Re: Draft Final Remedial Design/Remedial Action Work Plan, LHAAP-17 Burning Ground No. 2/ Flashing Area, Group 2, Longhorn Army Ammunition Plant, Karnack, Texas, March 2019

**Response to Comments on
Draft Remedial Design / Remedial Action Work Plan
LHAAP-17 Burning Ground No. 2 / Flashing Area, Group 2**

Reviewer: Mr. Richard Mayer, USEPA

Figure 2-2
Intermediate Zone Potentiometric Surface
(November 2017)
Remedial Design / Remedial Action Work Plan
LHAAP-17

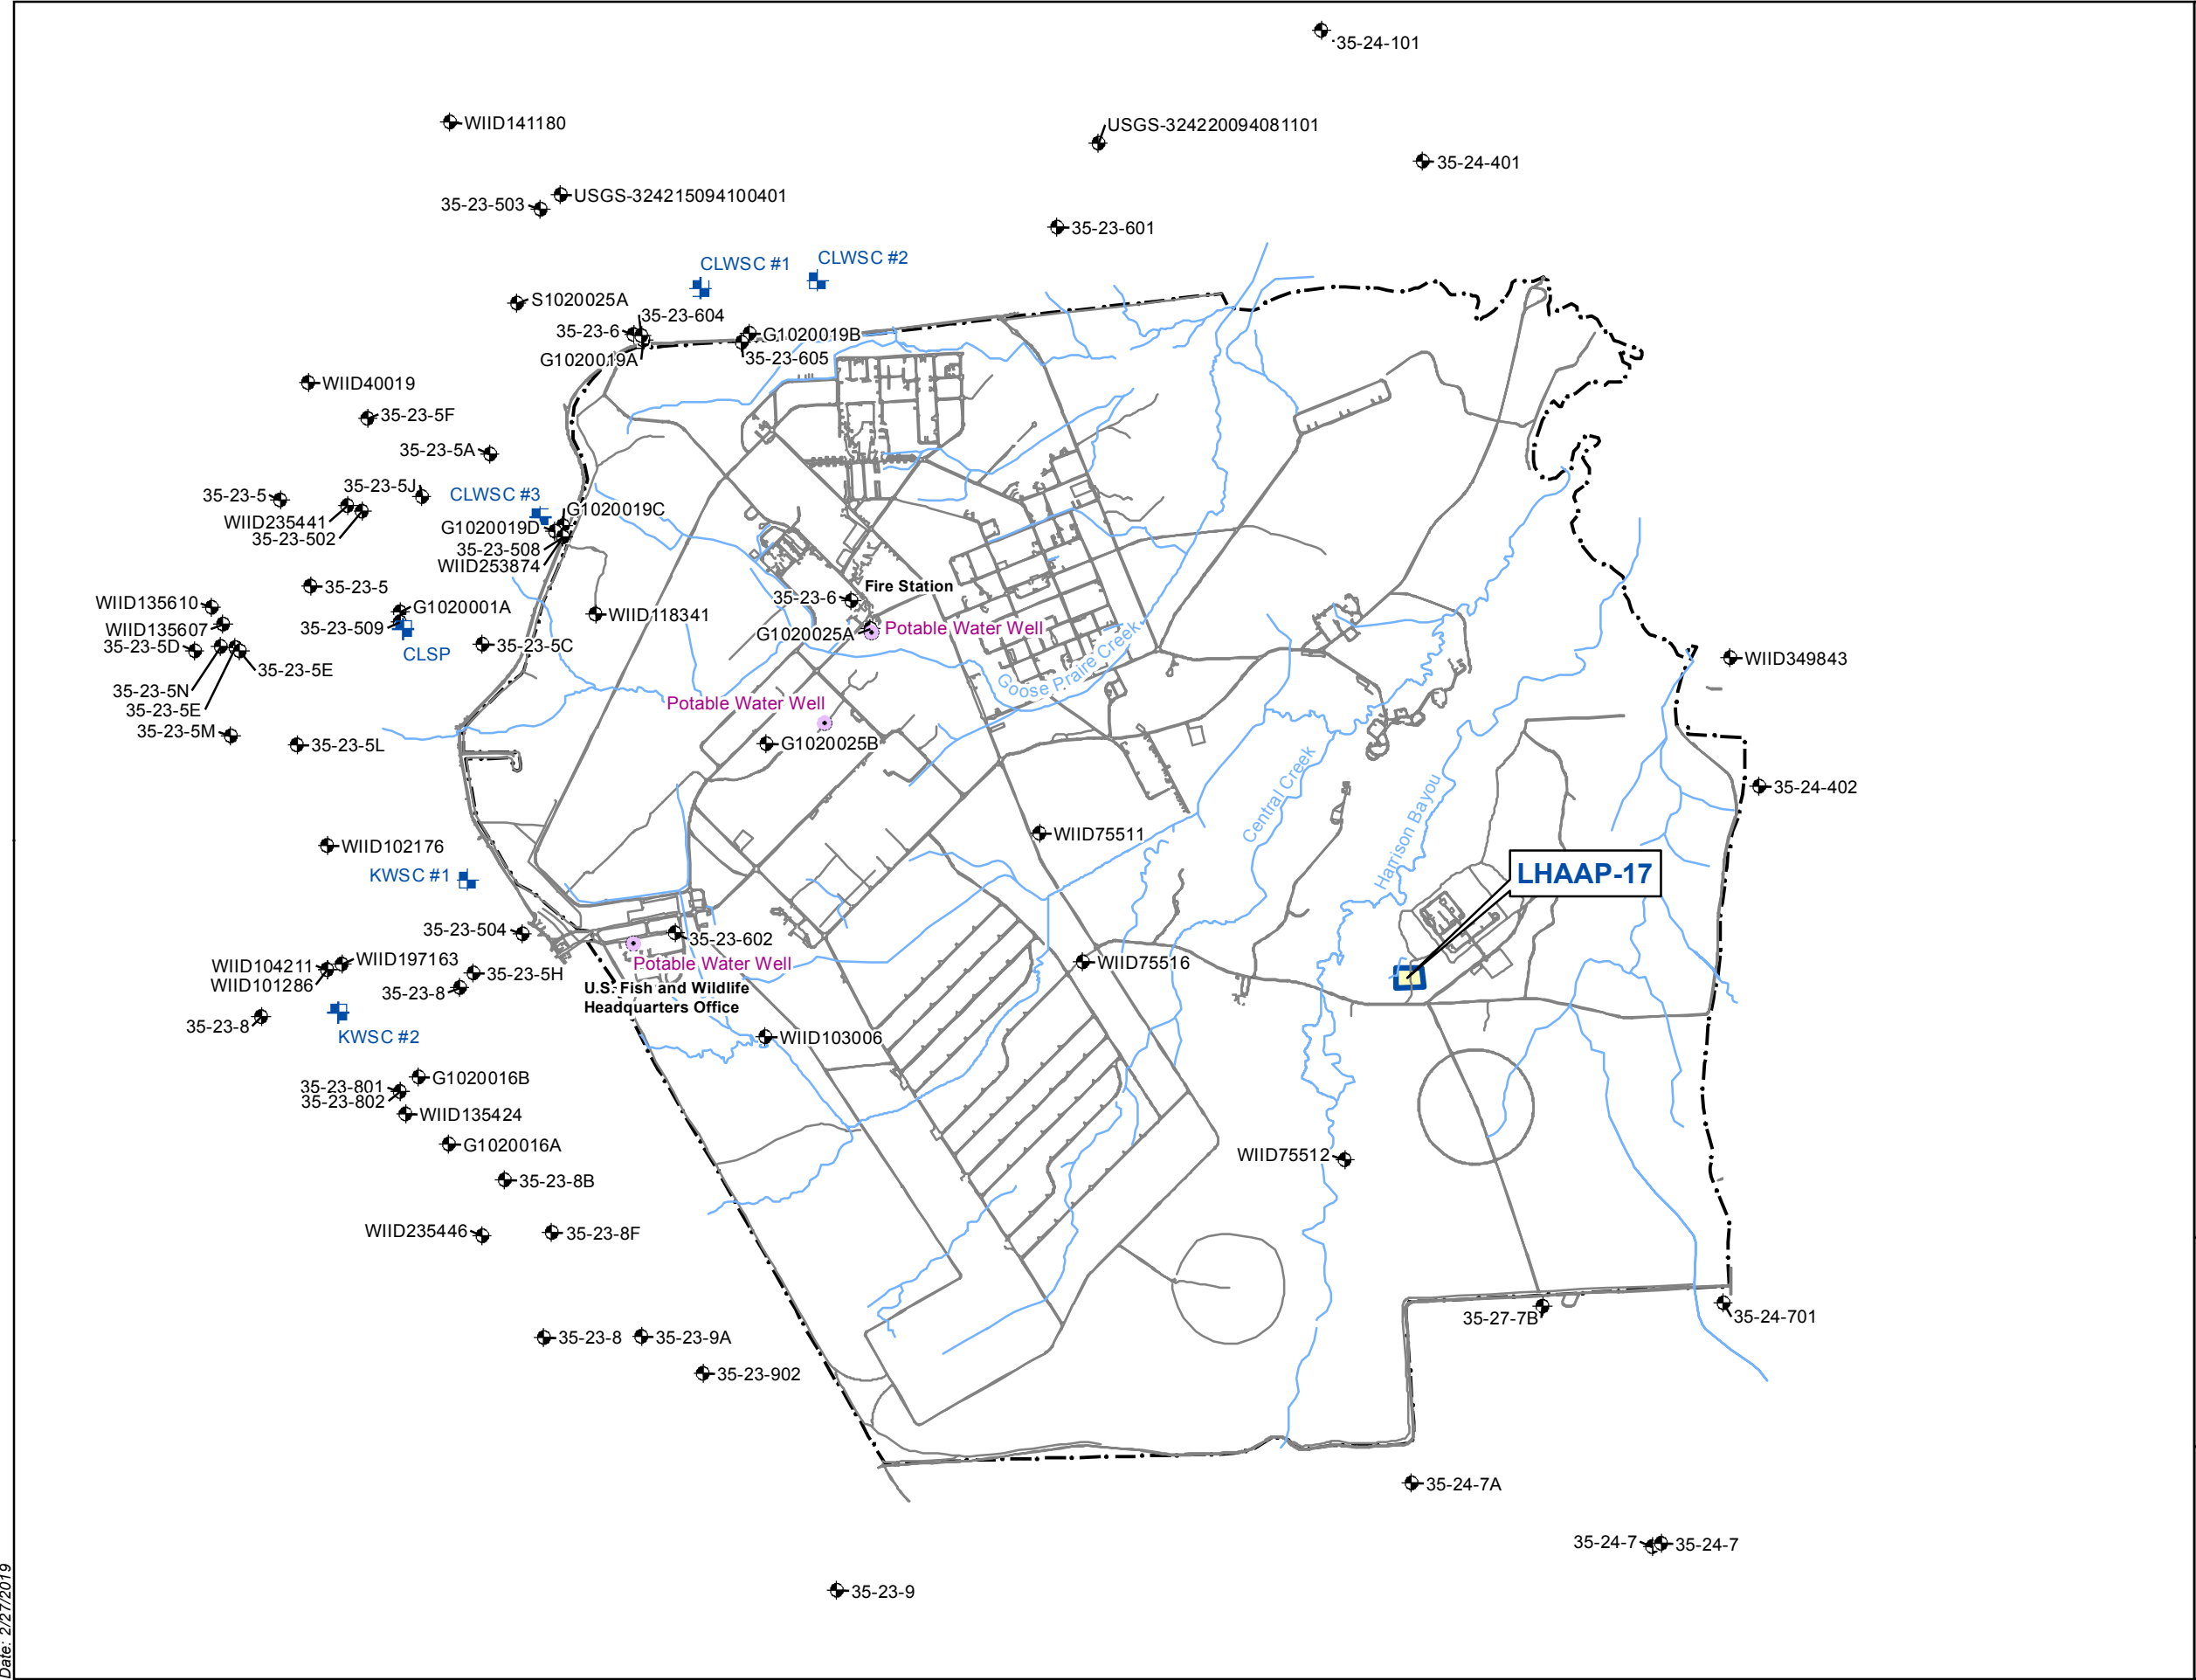
Comment No.	Section, Page ref.	USEPA Comment	C, D, E, or X ¹	Response	A or D ²
		Confined conditions are seen with most aquitards.			
5.	Figure 2-2	Monitoring well MW-20 is screened between a perched zone and the shallow groundwater. The southwest corner of LHAAP 18/24 has been known to have a perched zone, so it is questionable if the water levels at that location represent the first shallow water zone. However, since there are no other wells in that area that are in the shallow zone, the water levels are most likely similar to those in MW-7.	C	<p>It is assumed that the comment refers to Figure 2-1 instead of Figure 2-2, since neither of the wells referred to are shown on Figure 2-2. Reviewer is correct that MW-20 and nearby 18CPTMW22R are screened ~10' shallower than MW-7.</p> <p>The potentiometric surface figure for the Shallow Zone (Figure 2-1) has been revised to remove the contours above 168.6 and revise the contours to remove the influence of the two locations. The groundwater elevations for MW-20 and 18CPTMW22R are still shown, but a note has been added to the legend stating "The groundwater elevations for MW-20 and 18CPTMW22R were not used to draw potentiometric contours because they are screened significantly shallower than other nearby wells and may not represent elevations in the shallow zone."</p>

Figure 3-1

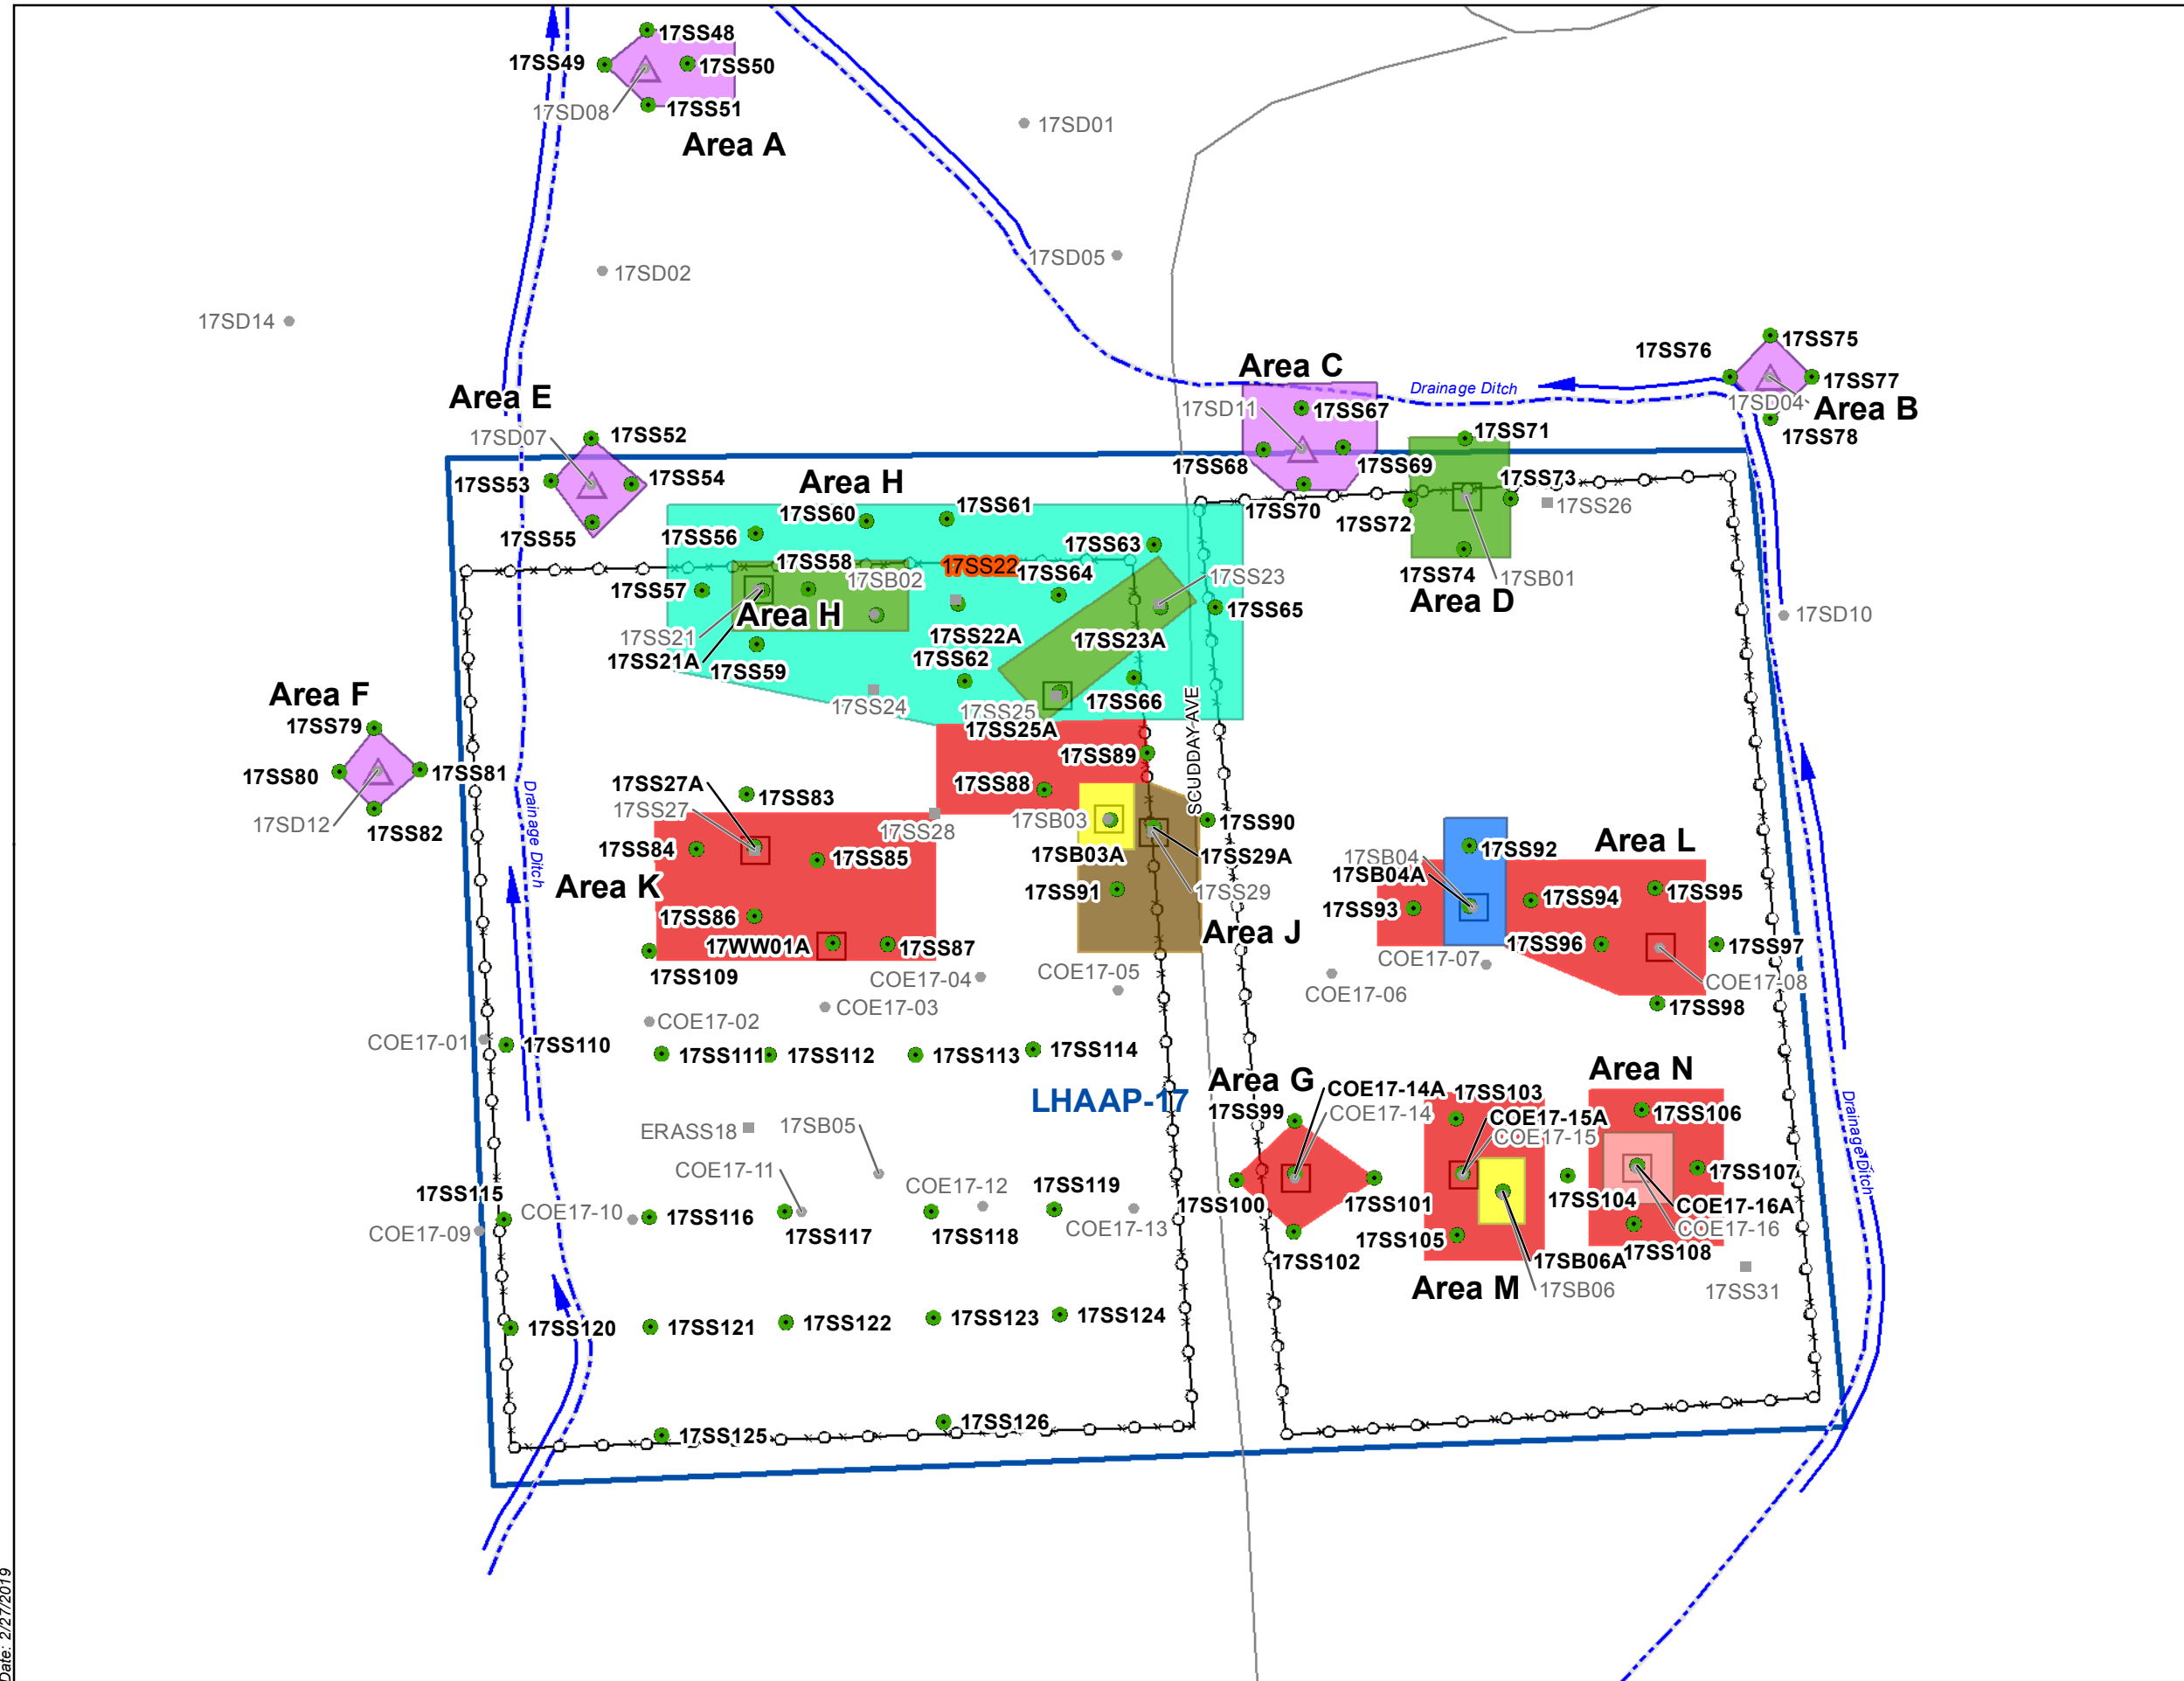
7.	Page 4-1, Section 4.2	The text refers to Figure 2-1, which should be Figure 3-1. EPA recommends adding the concentrations of explosives and barium that exceeded the health criteria to the Figure.	C/D	The text reference has been revised to refer to Figure 3-1. Each location shown as highlighted may have up to 3 different COC concentrations exceeding the health criteria at one or more depths. Adding the data (COC, depth, and concentration for each

Comment No.	Section, Page ref.	USEPA Comment	C, D, E, or X ¹	Response	A or D ²
				exceedance) to each location would make the figure extremely difficult to read and would obscure the primary purpose of showing the overall pattern of the soil areas requiring excavation. The title of the figure has been revised to “Soil Sample Locations with Concentrations Exceeding the Cleanup Levels” to clarify the purpose. A reference to Table 3-1 has been added to the legend of Figure 3-1.
